To: panel_dev@legco.gov.hk
From: Katty Law
Date: 11/09/2014 11:38AM
Subject: Objection to the proposed pumping station at the Flagstaff House Monument, Hong Kong Park

Assessment of Proposed Reprovisioning of Harcourt Road Fresh Water Pumping Station at Flagstaff House Declared Monument, Hong Kong Park

Ken Borthwick RIBA, RIAS, HKIA

Figure 2: Site for proposed Cotton Tree Drive FWPS and Study Area for HIA
Source: provided by WSD, modified by author

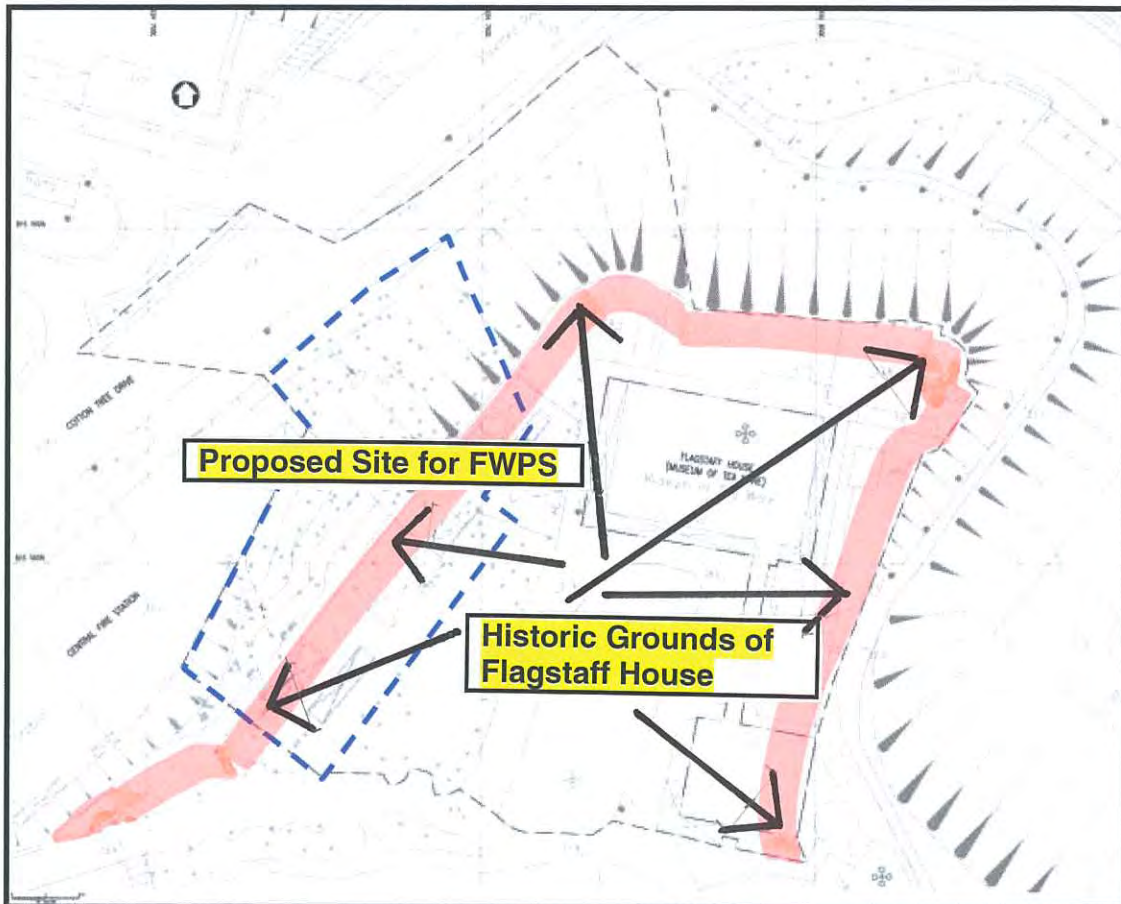
The site for the Pumping Station is described in WSD's Heritage Impact Assessment (HIA) as 'adjacent to the Central Fire Station at Cotton Tree Drive', being shown on Fig. 2 of the HIA (Copy attached as **Appendix A**). However, from examination of the HIA it can be seen that the site straddles the existing slope above Cotton Tree Drive, to the western side of the hillock, or elevated site (which gave Flagstaff House its strong defensive position overlooking the harbour) and extends underground to the east into what will have been Flagstaff House's original grounds, or garden, as delineated by a historic rubble masonry defensive wall, where its roof would be under the level of the grounds/ garden of the house. This historic wall sits on the crest of the slope up from Cotton Tree Drive. Roughly half way down the western boundary of the house, approximately level with the northern end of the Fire Station Compound, the barrier changes to a classical balustrade, whose lower part at that point acts as a retaining wall to support the garden of Flagstaff House above. The balustrade continues round to the north of Flagstaff House, where it reverts to being a masonry wall. It is considered that the original grounds, or garden, of Flagstaff House can be determined as being the masonry defensive wall and classical balustrade, by viewing an 1847 Lithograph of Flagstaff House, as well as an 1874 map which are included in the HIA as Fig. 22 and Fig. 23 on page 20 (Copy attached at **Appendix B**). The line of the wall/ balustrade can be clearly seen on the latter.

Figure 23: 1874 map
Source: *Victoria Barracks, 1842-1979*, modified by the author

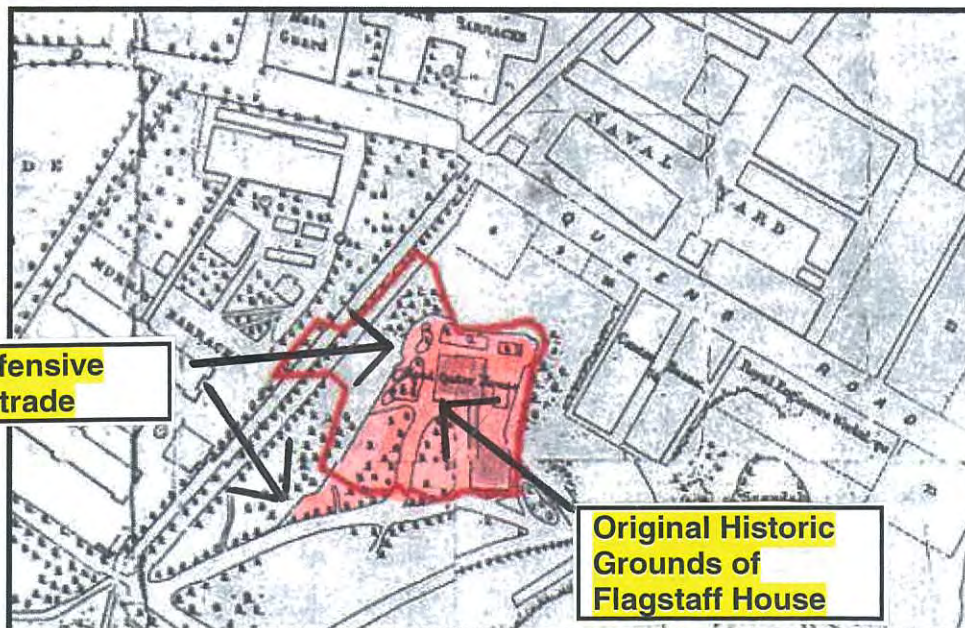
In his assessment (which closely examines aspects of WSD's HIA) Mr Borthwick looks at the original positioning of Flagstaff House on the crest of the slope, as well as at what he assesses to be its original grounds based on historical plans and early pictures of Flagstaff House in the HIA. He has made an assessment of an historic, rubble stone, fortified defensive wall with loopholes for firing through, which he opines may be the earliest example of British military fortification surviving in Hong Kong and a vital piece of historic evidence. WSD's HIA totally fails to identify this feature for what it is, nor assess its historical and cultural importance. Under WSD's proposals most of this historic feature (as well as a significant portion of its adjoining classical balustrade) would be destroyed and the context and meaning of the wall would be completely lost. He further cites clauses in the 'Principles for the Conservation of Heritage Sites in China', including Article 12 which stipulates the requirement to demarcate the boundaries of an historic site and that a

Historic Grounds of
Flagstaff House

Historic Defensive
Wall/ Balustrade

Original Historic
Grounds of
Flagstaff House

Figure 14: 1860 photo of the neighboring site, from where the stone wall is clearly seen (with Flagstaff House highlighted in red)
 Source: *Victoria Barracks, 1842-1979*

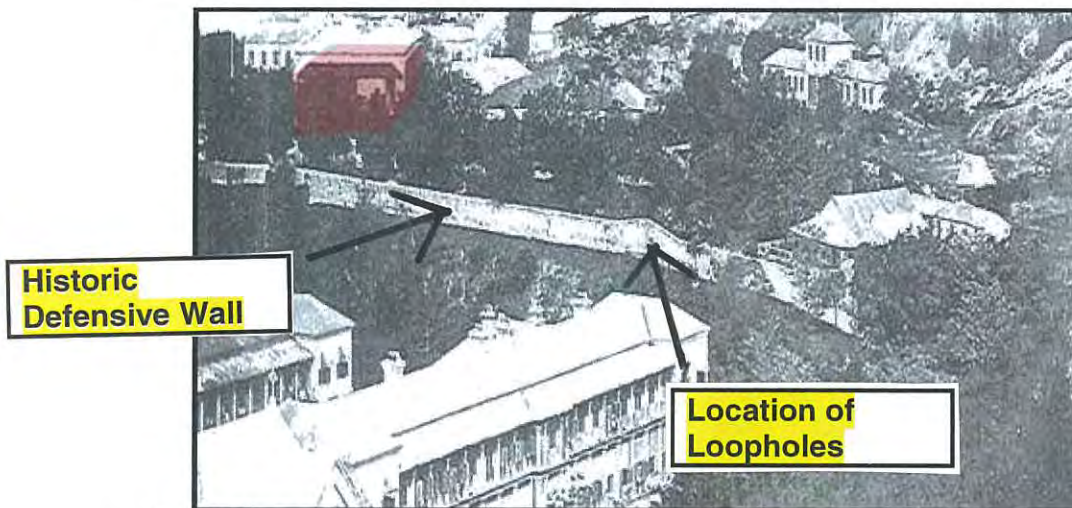
At its southern part, up to the point of transition, this feature comprises an approximately 550mm historic, squared, coursed rubble defensive wall. This wall can be plainly seen in an 1860 photograph included as Fig 14 in the HIA (copy attached at **Appendix C**). The date of this photo was only 14 years after the house was built. The exact date of construction of this wall is not known (and ideally further study on it should be made), however it is considered that this wall may be contemporary with the original construction of Flagstaff House in 1846. In this case it would likely be the earliest example of British defensive fortification existing in Hong Kong. In the background an 1846 lithograph shown on the cover of the Museum of Tea Ware Brochure can be seen a feature which may be this historic wall (Refer **Appendix D**).

Figure 15: 1993 plan
 Source: provided by WSD, modified by the author

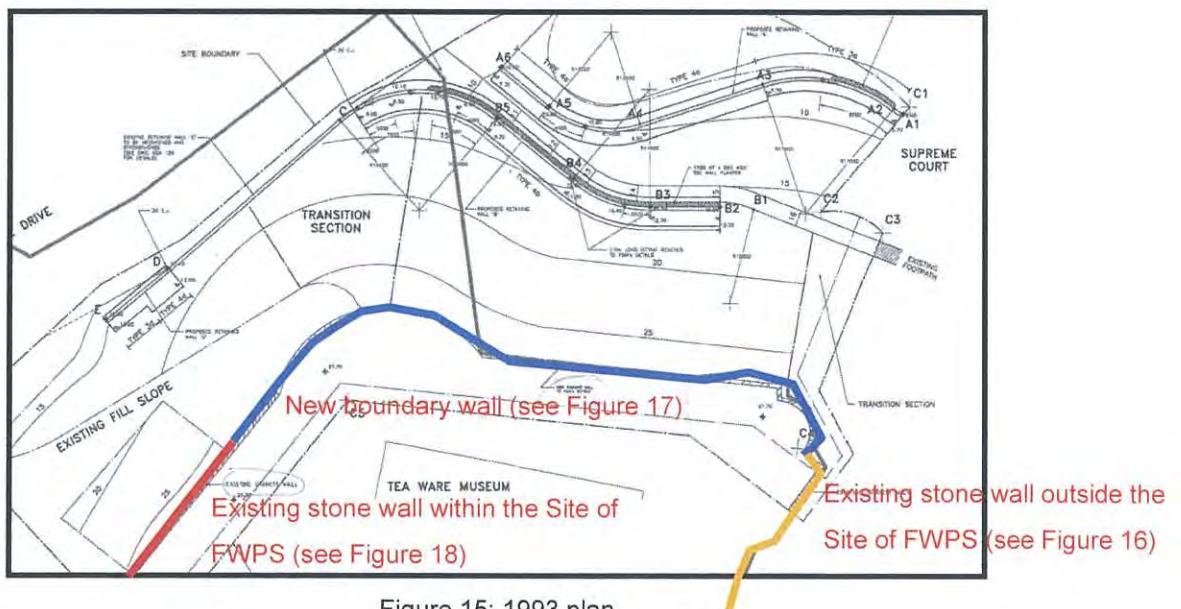
Possible Historic
Masonry
Defensive Wall

Figure A2.2: Proposed landscape layout plan
Source: provided by URBIS

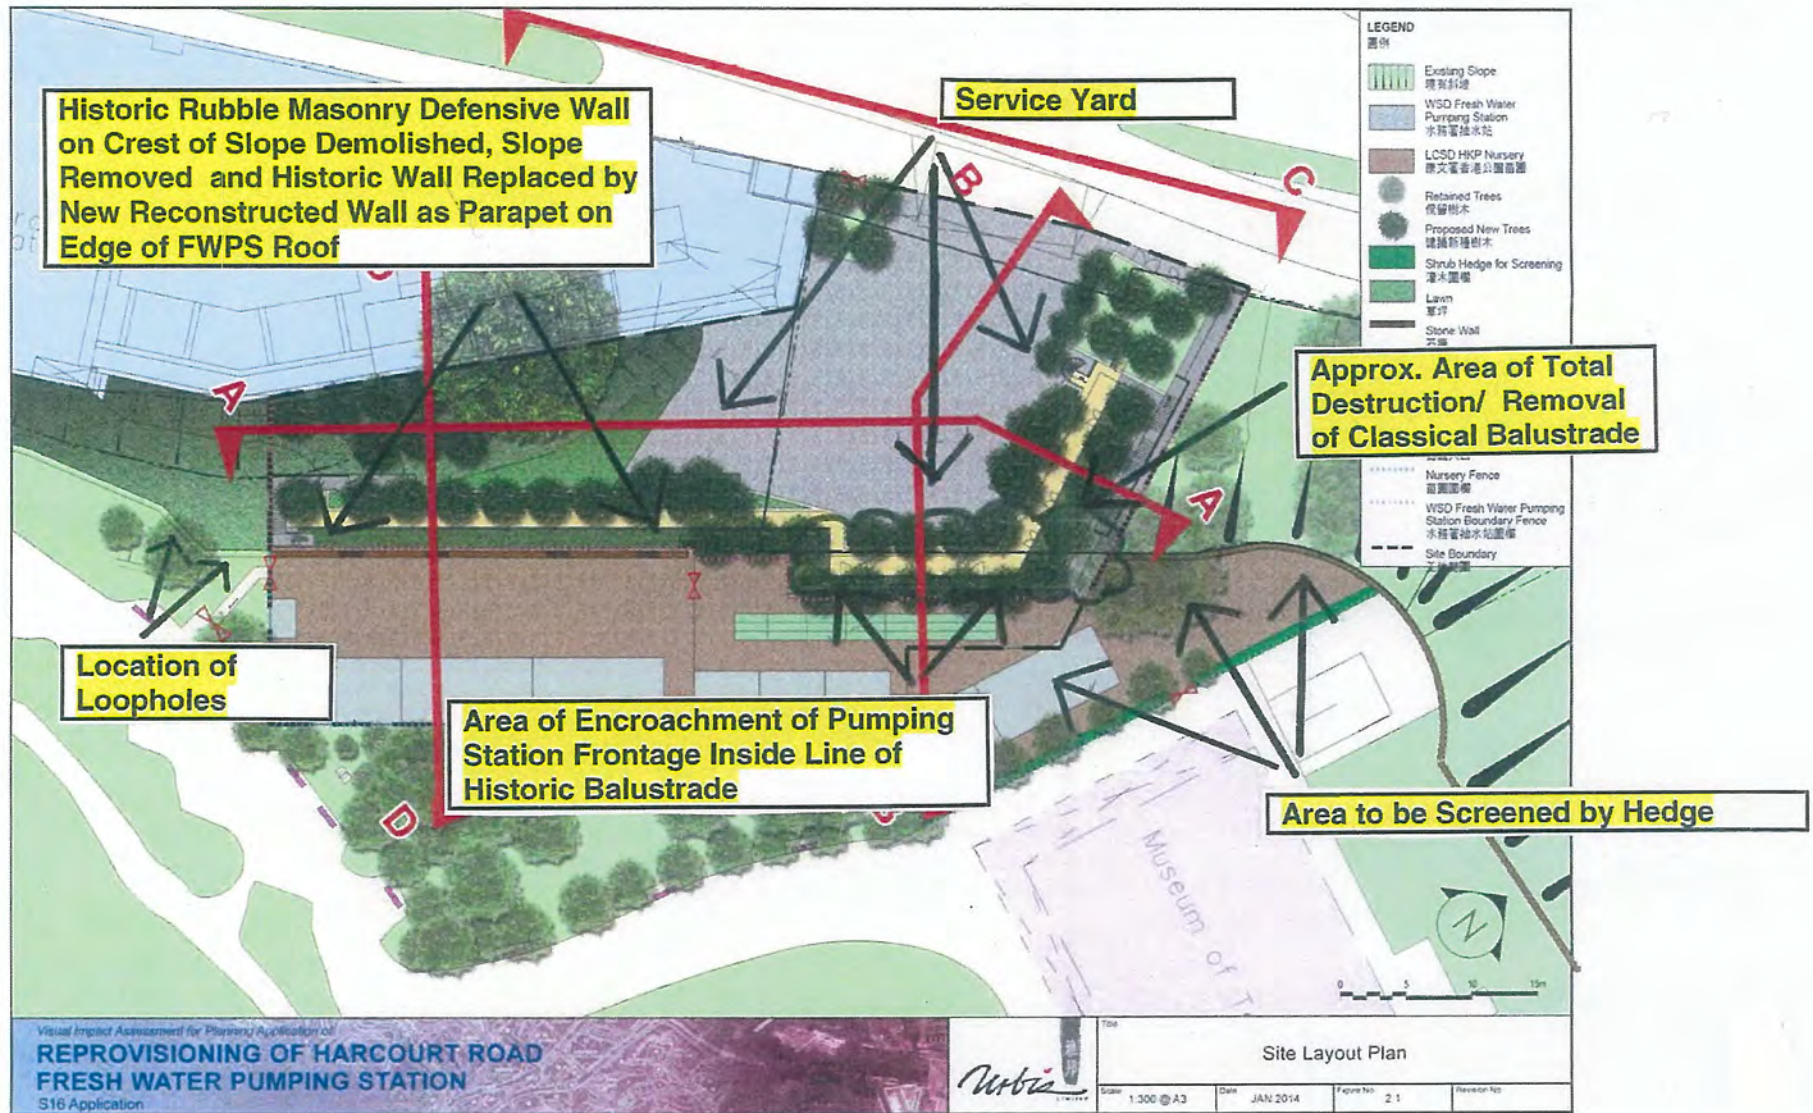
Although it is not stated in the text in the HIA, from the 'Landscape Layout Plan' included at Fig. A2.2 in the HIA (**Appendix G**) it can be seen that there would be a sizeable new vehicle run-in from the lower part of Cotton Tree Drive, inside which appears to be a sizeable hard paved service yard (see marked-up copy of the plan at **Appendix G**), which would front what is indicated as the two- step façade of the Pumping Station. At approximately mid point in its height the Pumping Station façade would have a small planter where small trees are indicated (See Fig 2.4 and 2.5 attached as **Appendix H**). At the northern end of this service yard there would be what appears to be a massive masonry- faced retaining wall, again with small trees in planters.

Such a hard service yard with hard face of Pumping Station on its eastern side and high retaining wall on its north side, with only a comparatively small section of much lower height slope being reformed behind the Fire Station Compound would result in the destruction of a sizeable portion of a beautiful historic slope bordering Flagstaff House, with dense tree cover, which at present constitutes an area of very high visual amenity (See photos at **Appendix E**).

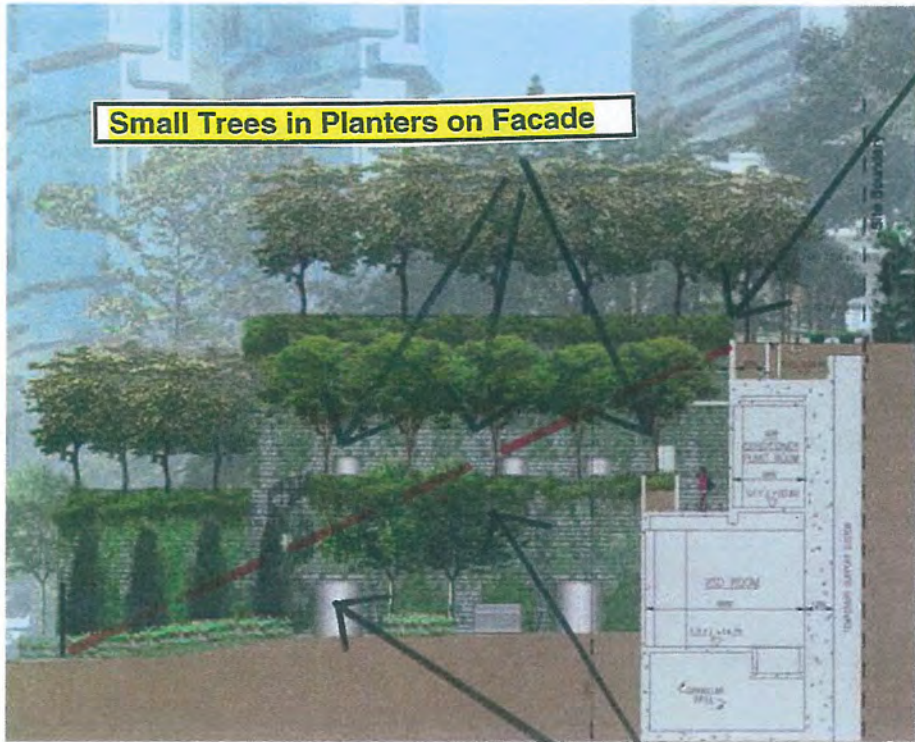
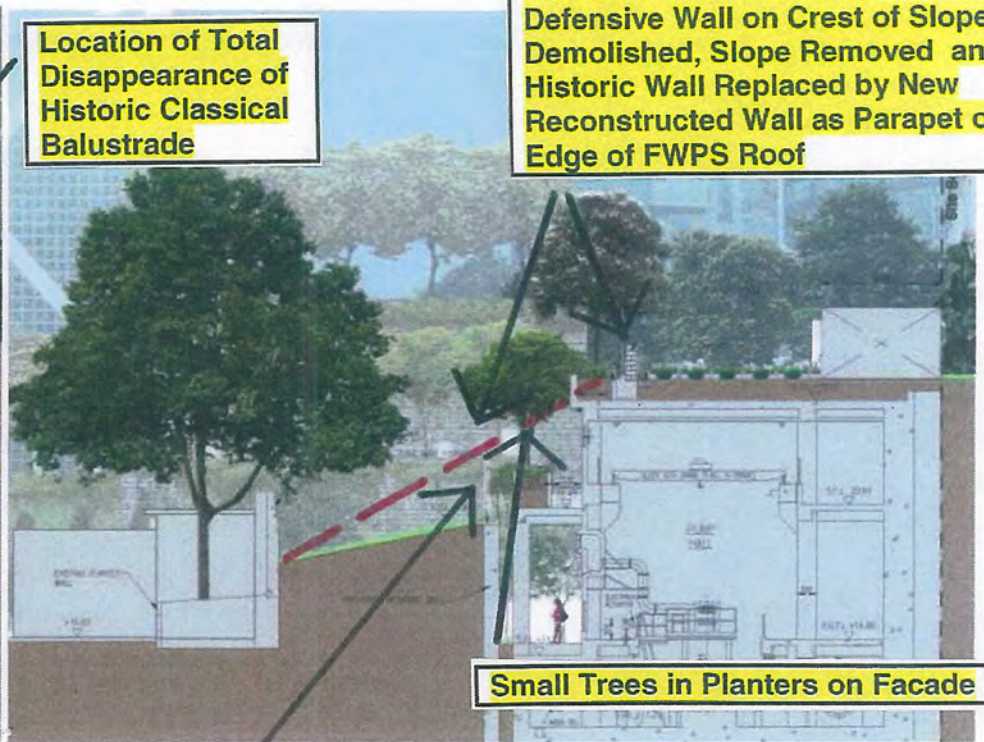
WSD's proposal allows for the rebuilding at its southern part of a section of rubble stone wall roughly on the alignment of the existing historic defensive wall. On review, however, of certain of the landscape plans and sections in the HIA, it can be seen that at the northern part of the Pumping Station site, the alignment of the face of the Pumping Station extends some distance inside the historic boundary of Flagstaff House as delineated at that point by the historic classical balustrade to the west of Flagstaff House itself and it appears that only a glass balustrade or similar would be provided at that point as a barrier to the edge of the Pump House below which would now be located well inside the Flagstaff House garden. The historic classical balustrade would cease to exist at that point and the historical context would be entirely lost.

Approx. Area of Cut Slope

Figure 6: Separation between pumping station and monument
Source: provided by WSD, modified by author

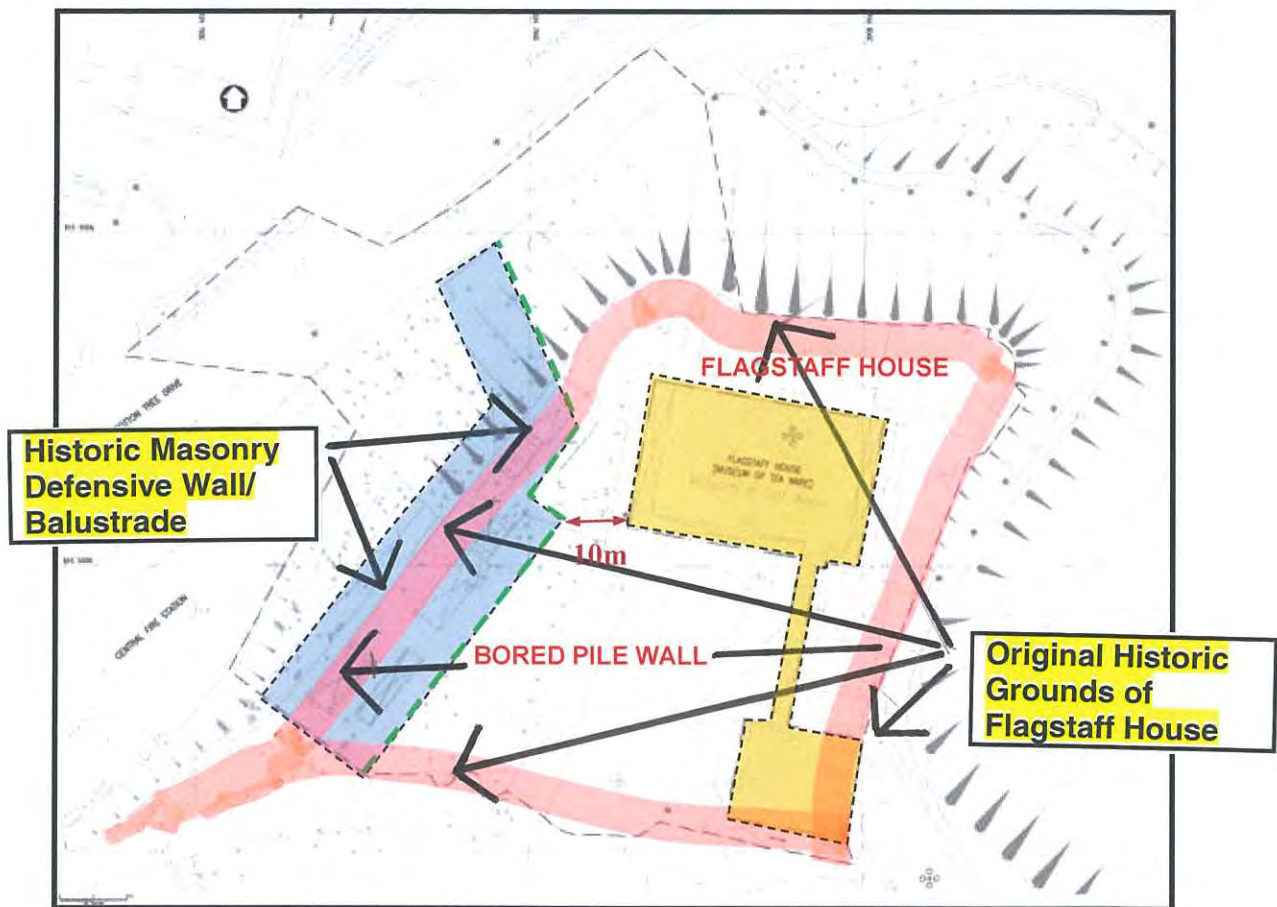
As indicated in (a) above, the site of the Pumping Station itself is located largely under the historic grounds, or garden, of Flagstaff House as delineated by the historic wall and classical balustrade. At its closest point the site extends almost to a corner of Flagstaff House itself. In order to construct the Pumping Station under the historic grounds of Flagstaff House, as well as at the historic slope down to Cotton Tree Drive, a massive bored pile wall is planned, as shown on Fig. 6 in the HIA, (attached at **Appendix J**). The bored pile wall would be constructed up to a distance of only 10 metres or so from the south west corner of Flagstaff House. Construction of such a massive bored pile, as stated up to a point very close to Flagstaff House itself, as well as the massive excavation works at the slope and within the historic both within the area enclosed by the bored pile wall and likely beyond, would be hugely intrusive and damaging to the site and setting of the Monument. The works would likely involve the use of heavy plant and equipment, both for the massive excavation works and for the construction of the bored pole wall.
